Proposed Baseline text for:
**Chip-to-module 25 Gb/s one-
lane Attachment Unit Interface
(XXVAUI-1)**

Molex

Jan. 5 2015

Figure X+4B-1—Example XXVAUI-1 chip-to-module relationship to the ISO/IEC Open System Interconnection reference model and the IEEE 802.3 CSMA/CD LAN model

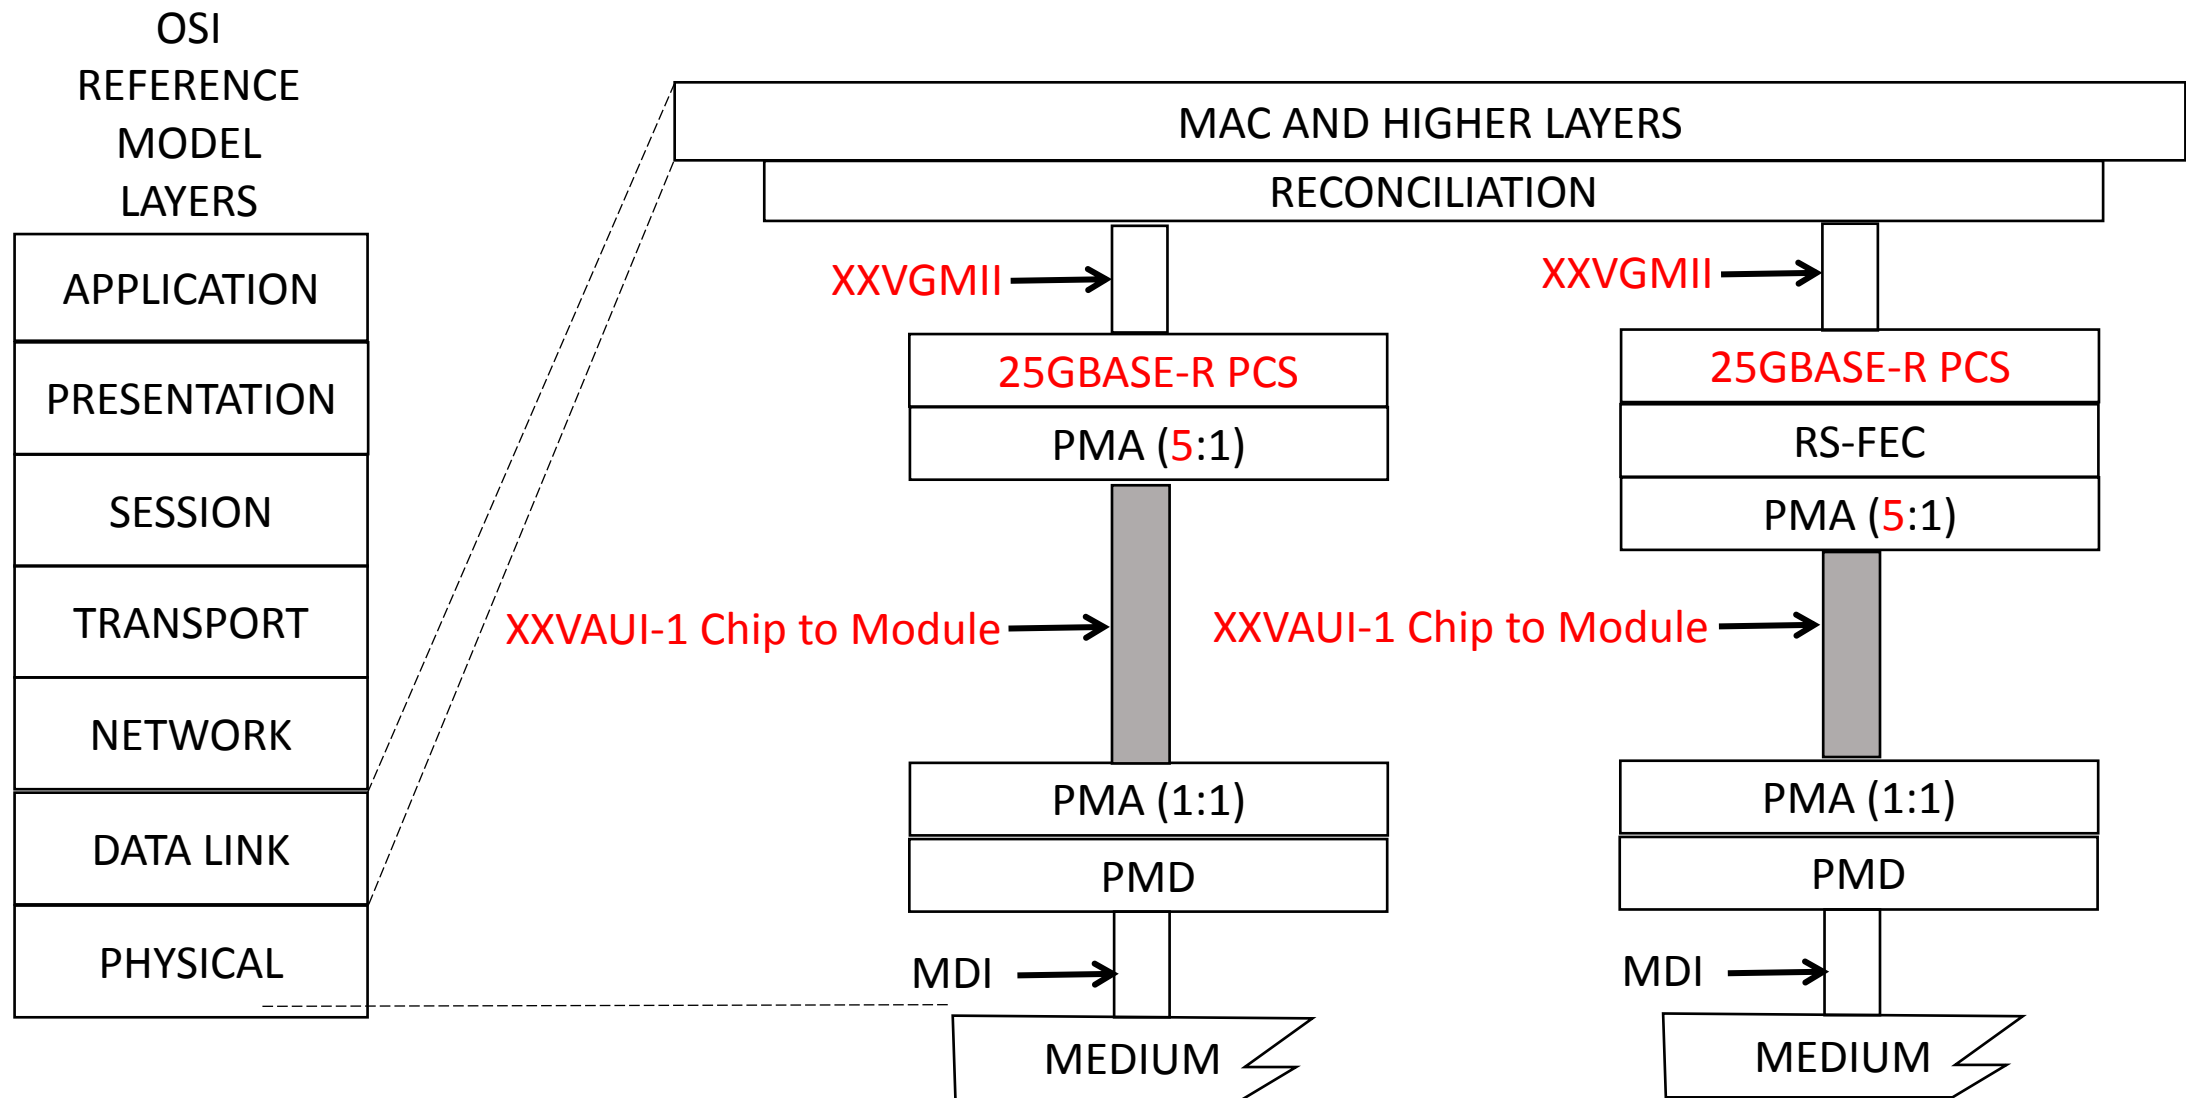
- Heavily leverages 802.3bm Annex 83E (CAUI-4 Chip to Module)
 - Changes to Intro text
 - Changes to ISO diagram and application diagram
 - Changes to PICS pro forma 'protocol summary' and 'major capabilities/options' tables
 - All other sections referenced directly with change from '4 lane' to '1 lane'

This annex defines the functional and electrical characteristics for the optional chip-to-module **25 Gb/s One-lane Attachment Unit Interface (XXVAUI-1)**. Figure **X+4B-1** shows the relationship of the **XXVAUI-1** chip-to-module interface to the ISO/IEC Open System Interconnection (OSI) reference model. The chip-to-module interface provides electrical characteristics and associated compliance points which can optionally be used when designing systems with pluggable module interfaces.

Figure X+4B.2: Chip-to-module insertion loss budget at 12.89 GHz

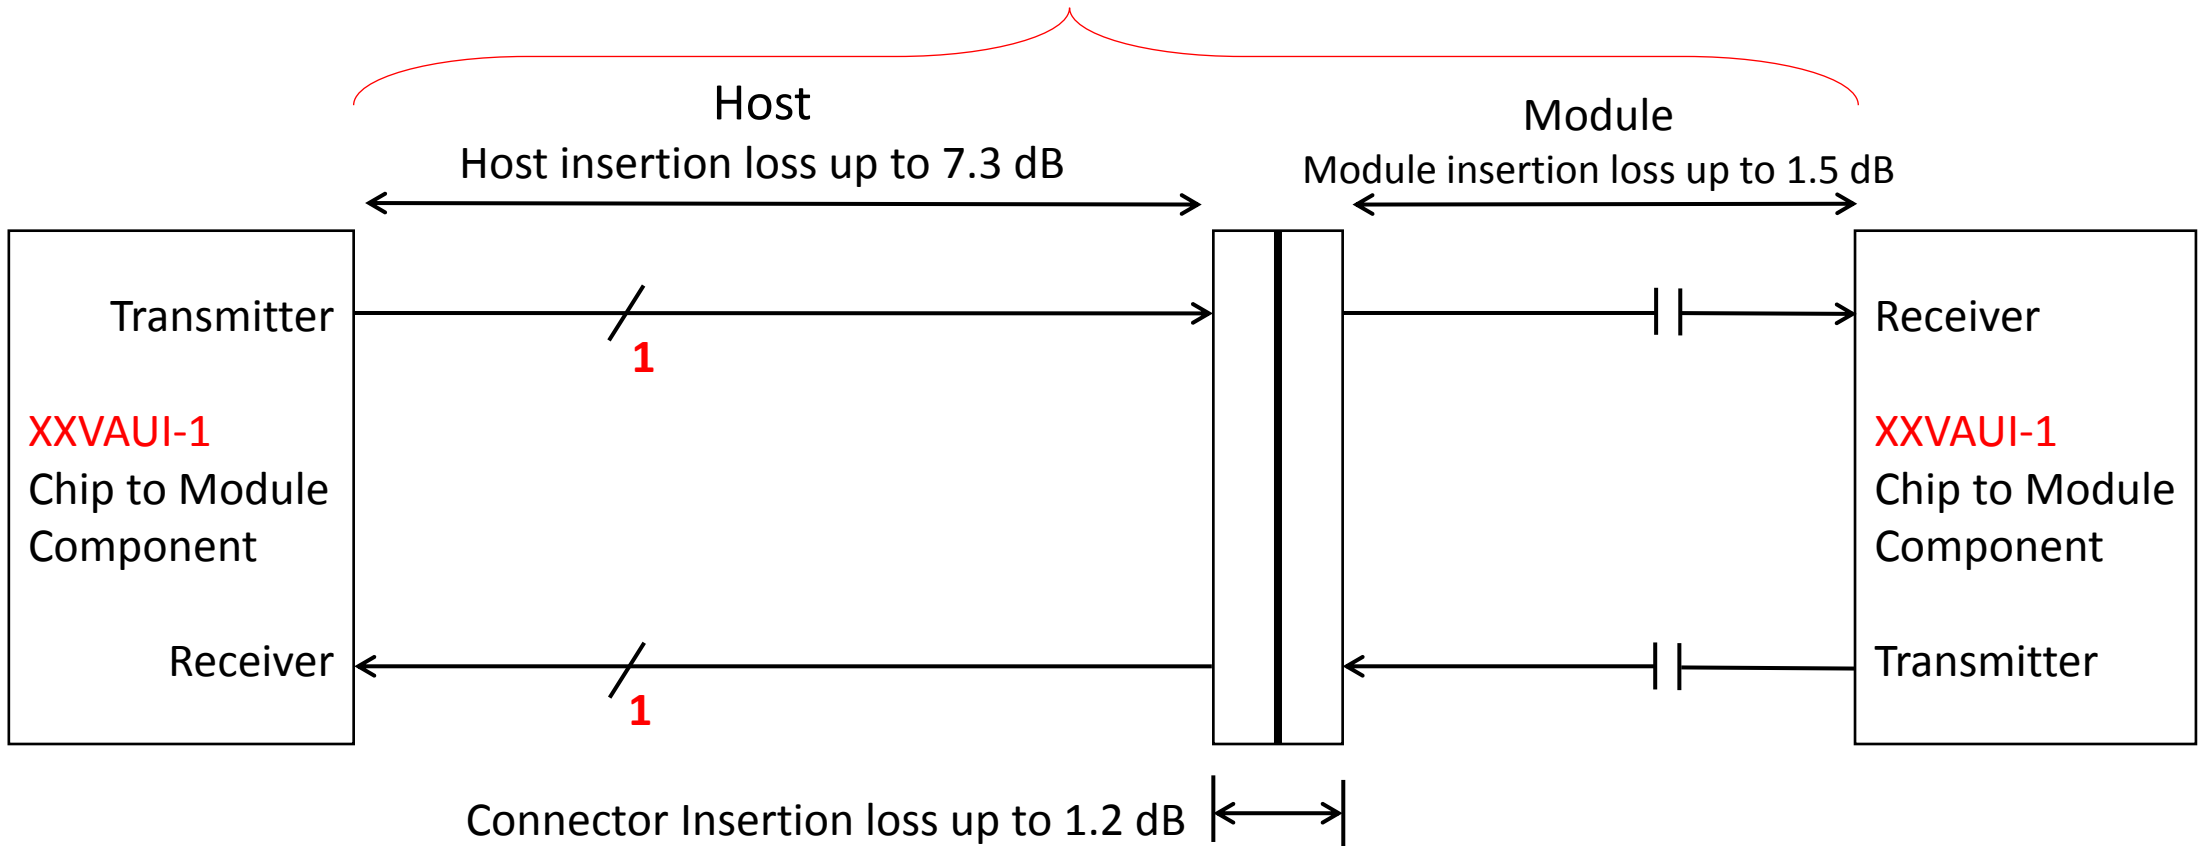
The **XXVAUI-1** link is described in terms of a host **XXVAUI-1** component, a **XXVAUI-1** channel with associated insertion loss, and a module **XXVAUI-1** component. Figure **X+4B-2** depicts a typical **XXVAUI-1** application, and summarizes the differential insertion loss budget associated with the chip-to-module application. The **XXVAUI-1** chip-to-module interface comprises independent data paths in each direction. Each data path contains **one** differential lane which is AC coupled within the module. The nominal signaling rate is 25.78125 GBd. The chip-to-module interface is defined using a specification and test methodology that is similar to that used for CEI-28G-VSR defined in OIF-CEI-03.1 [Bx1].
